Access Compliance Report Public Rights-of-Way (Curb Ramps)

Main Street: VANDERLIP_AVE Cross Street: CLARISSA_LN Location: SE

ADA ID: RPAT211006090800 Ramp Type: Type 1 - Perpendicular Diagonal Initial Pass/Fail: Fail Overall Compliance: No Severity Score: 15

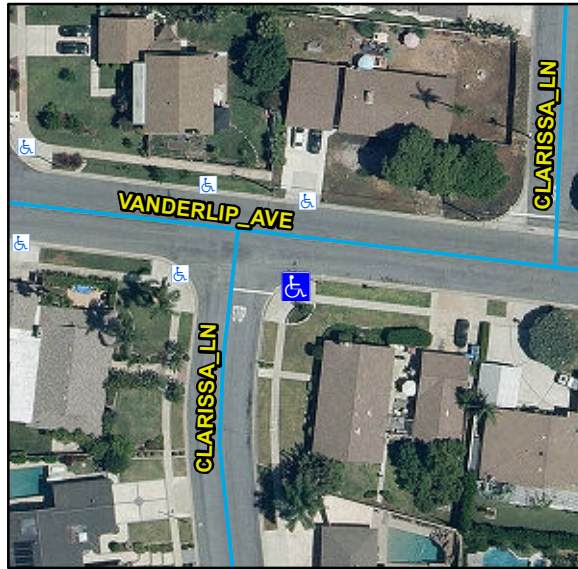
R204.3, R304.2.2, STD 1115

Remove & Replace Curb Ramp With Two New Directional Ramps or Equivalent.
